NABCO ENTRANCES TECHNICAL BULLETIN

Model 710 Door Frame Drilling Details

Bulletin Number: 30

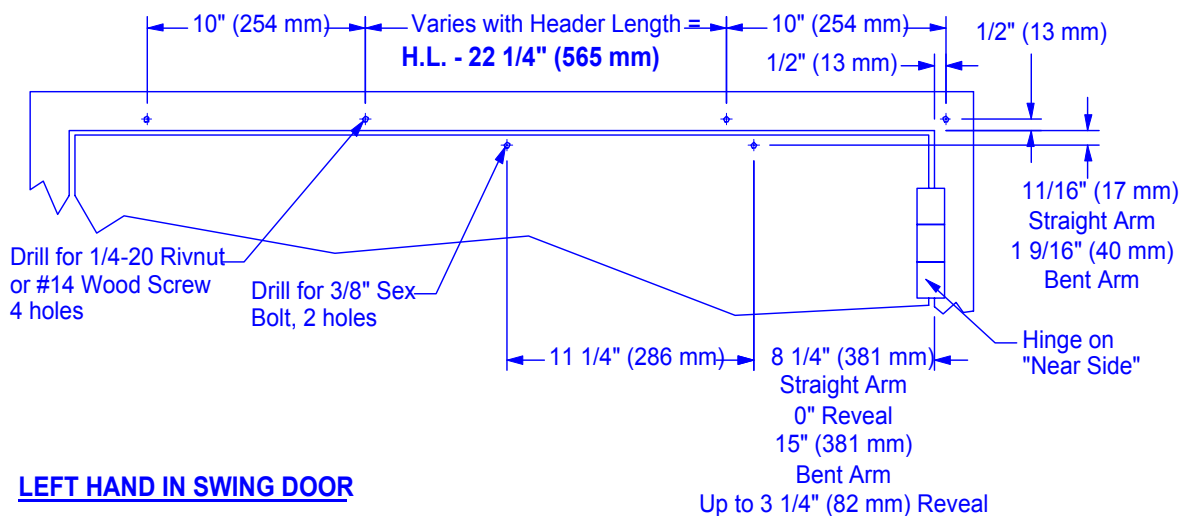
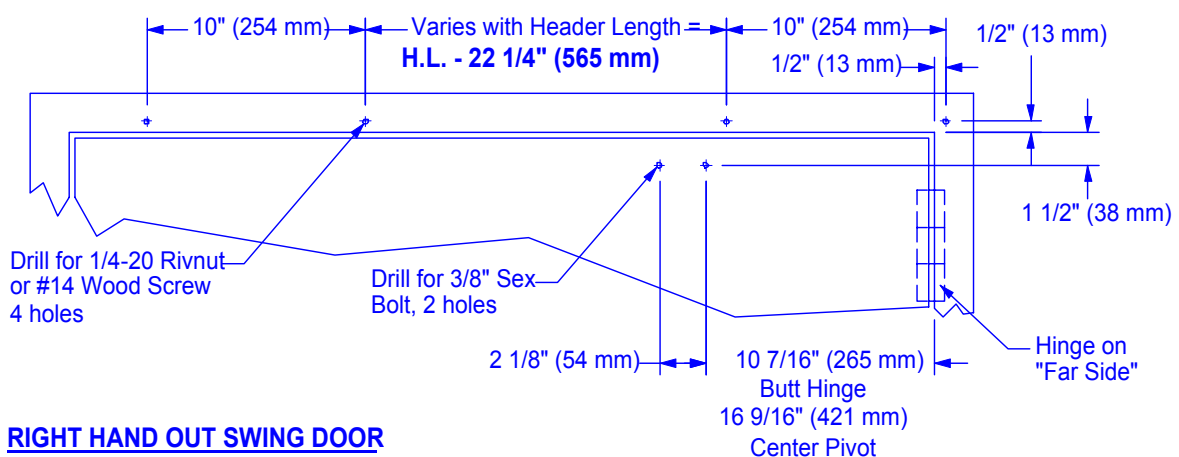
The Model 710 Header End Cap material thickness was revised in February 2001. The frame drilling details on page 6 of the Instruction Manual P/N 125660 should have been revised to reflect the material thickness change. Thus, locating frame screw holes to align with the header mounting screw holes. The appropriate 22-¼ inch dimension is shown below.
